Access Compliance Report Public Rights-of-Way (Curb Ramps)

Intersection ID: 13225 Main Street: MOREHEAD SQUARE DR Cross Street: E CARSON BV Location: NE

ADA ID: 6997EC4DCE03 Ramp Type: Perp Initial Pass/Fail: Fail Overall Compliance: No Severity Score: 12.5

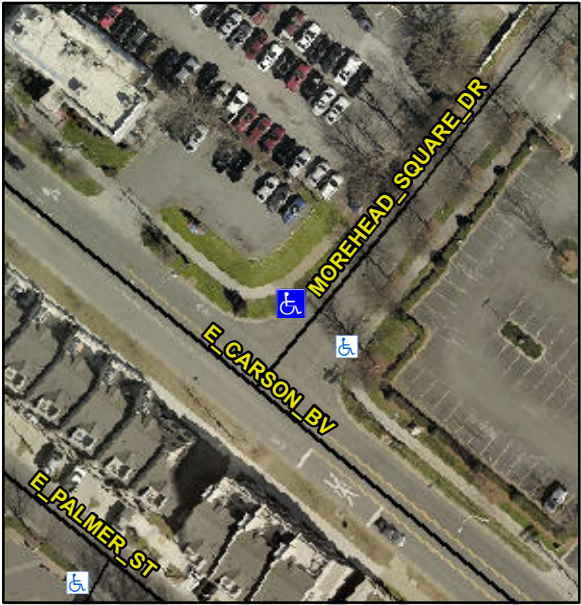
PROW/ADA:
Not Found, R304.2.2

Compliance	Description	Data	Compliance	Description	Data
N/A	Ramp Length (in)	130.0	No	Ramp Slope (%)	9.2
Yes	Ramp Width (in)	72.0	Yes	Ramp XSlope (%)	0.5
N/A	Flare Type LT	N/A	N/A	Flare Type RT	N/A
N/A	Flare Slope LT (%)	N/A	N/A	Flare Slope RT (%)	N/A
N/A	Flare Traversable LT?	N/A	N/A	Flare Traversable RT?	N/A
N/A	Landing Length (in)	N/A	N/A	DWS Provided?	N/A
N/A	Landing Width (in)	N/A	N/A	DWS Contrast?	N/A
N/A	Landing Slope (%)	N/A	N/A	DWS Length (in)	N/A
N/A	Landing X Slope (%)	N/A	N/A	DWS Full Width?	N/A
N/A	Landing Curb? (Y/N)	N/A	N/A	DWS Offset (in)	N/A
N/A	Shared Landing?	N/A			
N/A	Gutter Ponding?	N/A	N/A	Gutter Slope (%)	N/A
N/A	Gutter Lip Ht (in)	N/A	N/A	Gutter X Slope (%)	N/A
N/A	Painted X Walk1?	No	N/A	Painted X Walk2?	N/A
	X Walk 1 Direction	To SE		X Walk 2 Direction	N/A
N/A	X Walk 1 Width (in)	N/A	N/A	X Walk 2 Width (in)	N/A
	X Walk 1 Slope (%)	2.5		X Walk 2 Slope (%)	N/A
	X Walk 1 X Slope (%)	1.0		X Walk 2 X Slope (%)	N/A

Possible Solutions:
Remove & Replace Entire Ramp.
